**RE: Nobis Rehab Hospital
1100 Woodward Place NE
Grading and Drainage Plan
Engineer's Stamp Date: 10/16/25
Hydrology File: J15D053
Case # HYDR-2025-00428**

Based upon the information provided in your submittal received 12/02/2025, the Grading & Drainage Plans are approved for Building Permit, and Grading Permit. Please attach a copy of this approved plan in the construction sets for Building Permit processing along with a copy of this letter.

DRAWN BY	DATE	DRAWING	SHEET #	JOB #
pm	10-16-25		GR-1	2023123

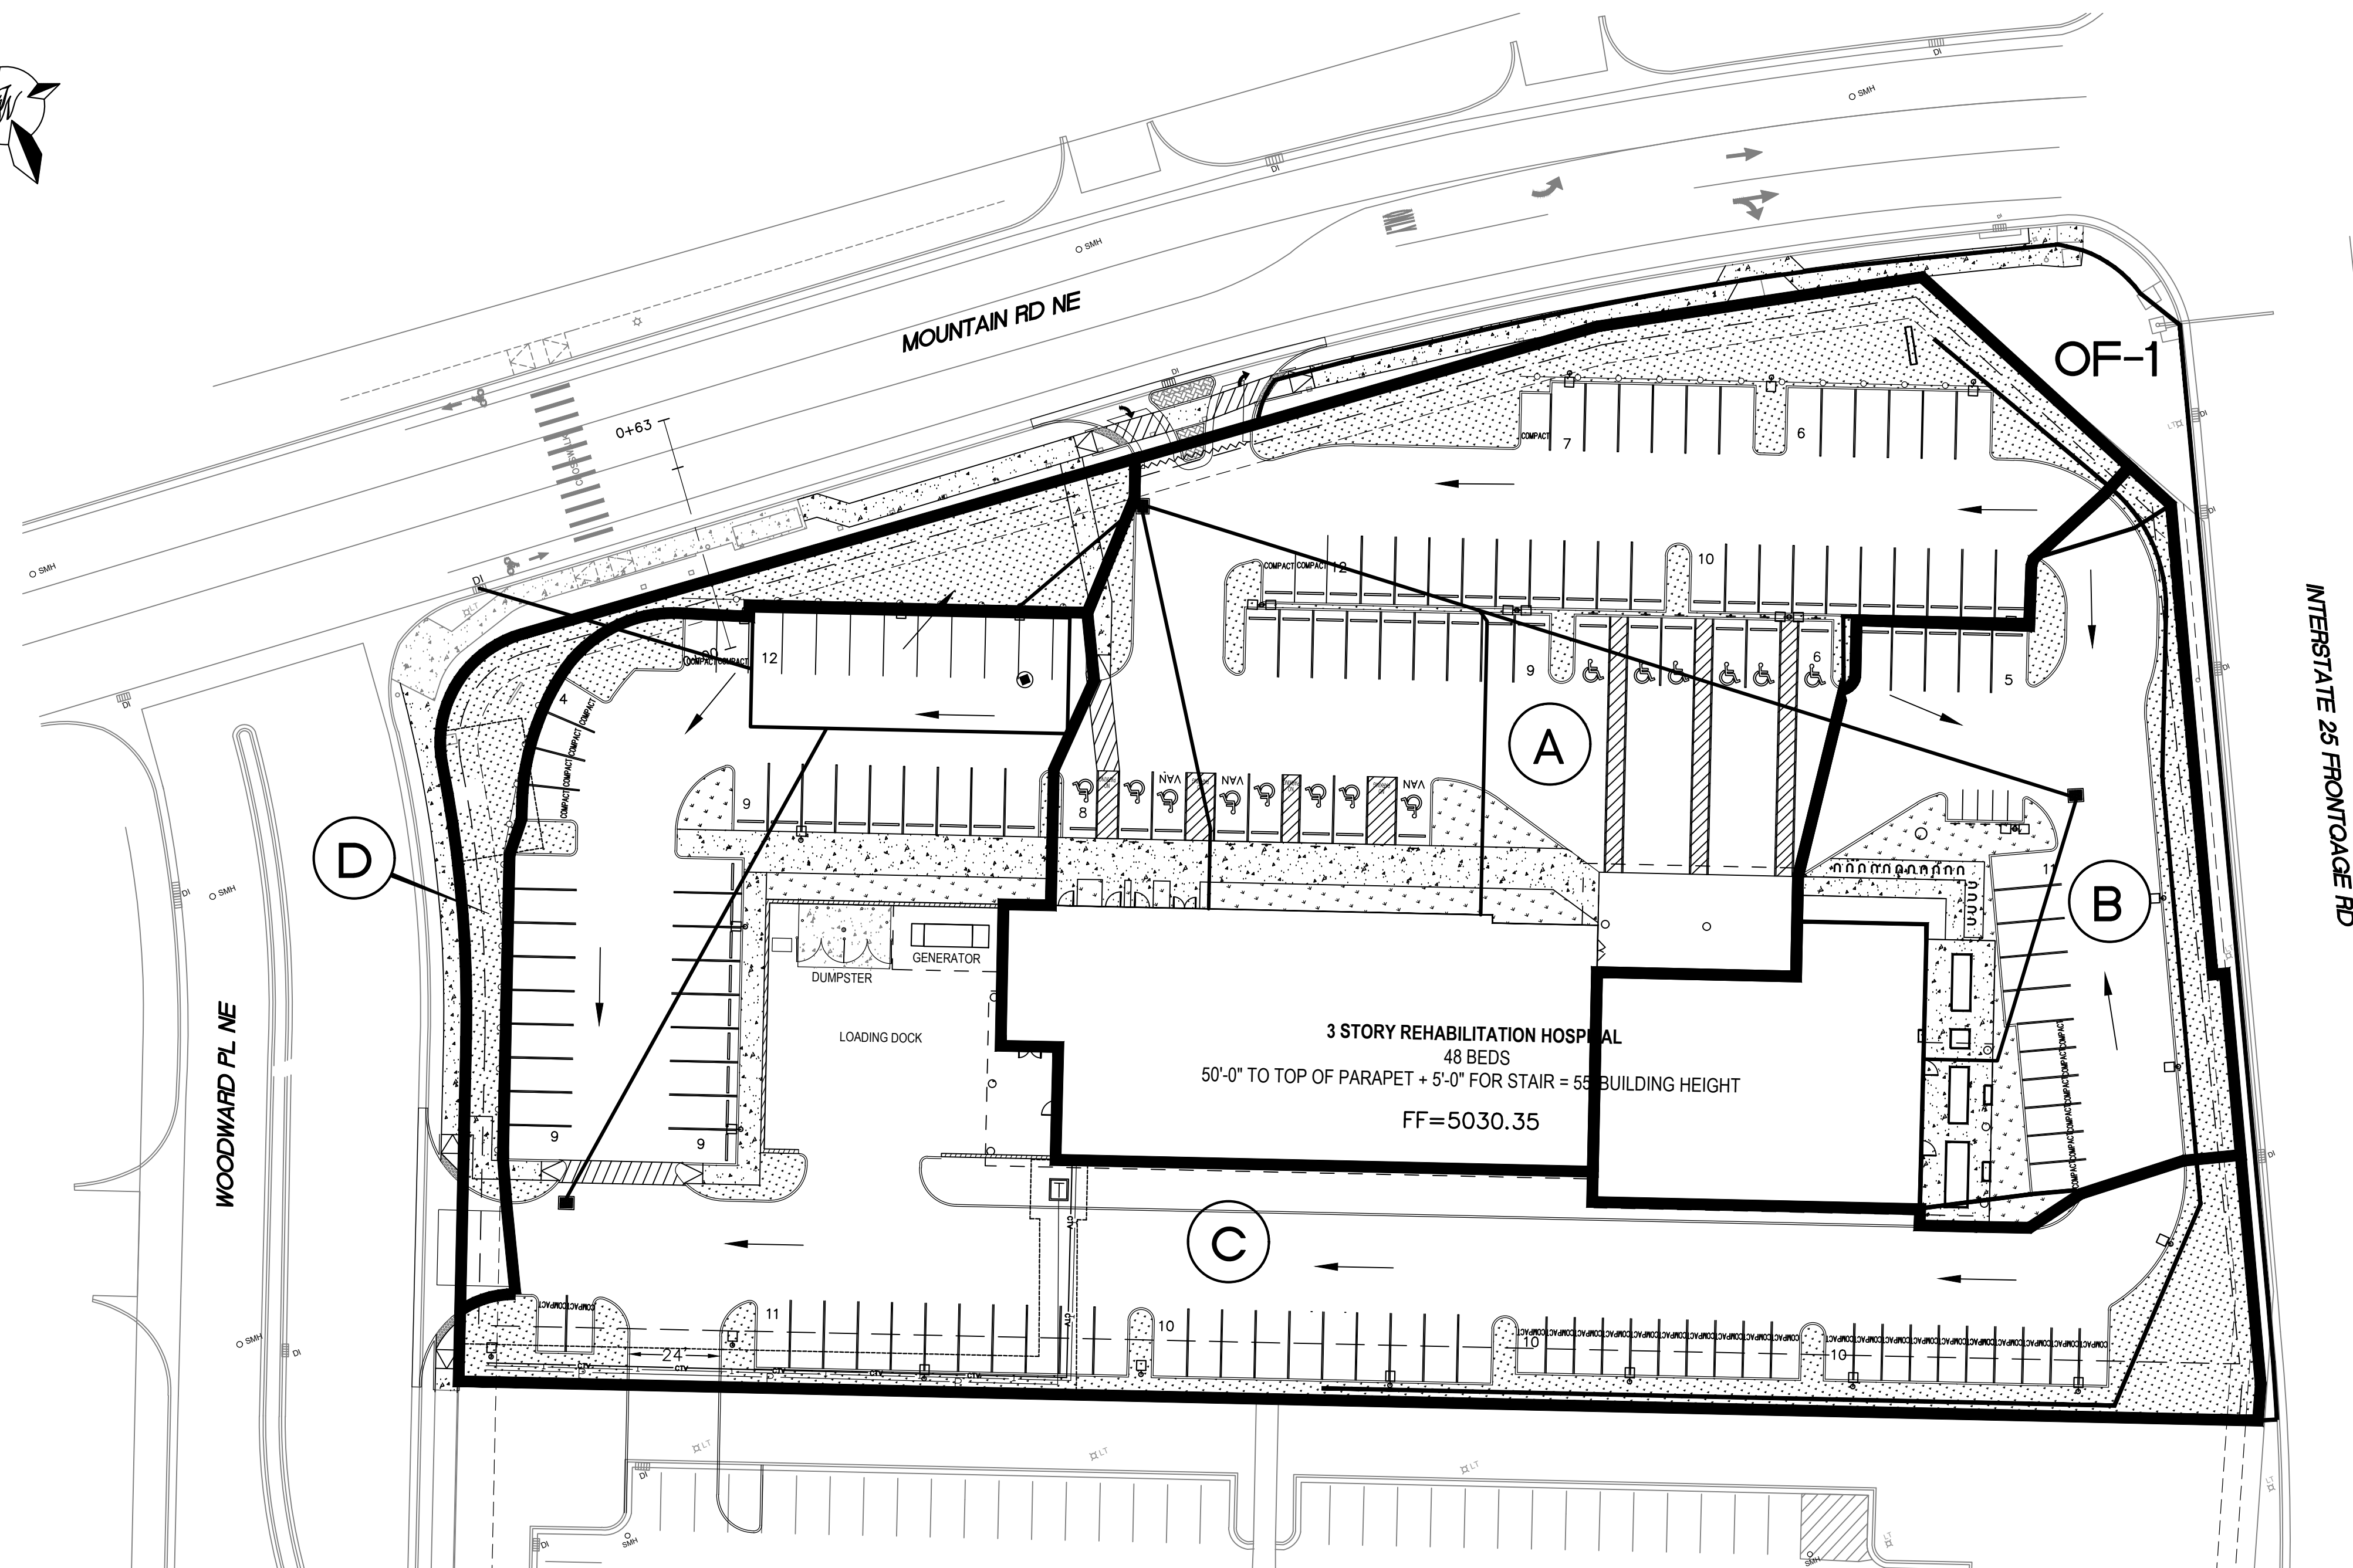
1. Engineer's Certification, per the DPM Part 6-14 (F): *Engineer's Certification Checklist For Non-Subdivision* is required.
2. Prior to the backfill of the underground detention system, please compose an Engineer Certification letter for the underground detention system with construction photos. This letter must be included in the Grading & Drainage submittal for Permanent Release of Occupancy.
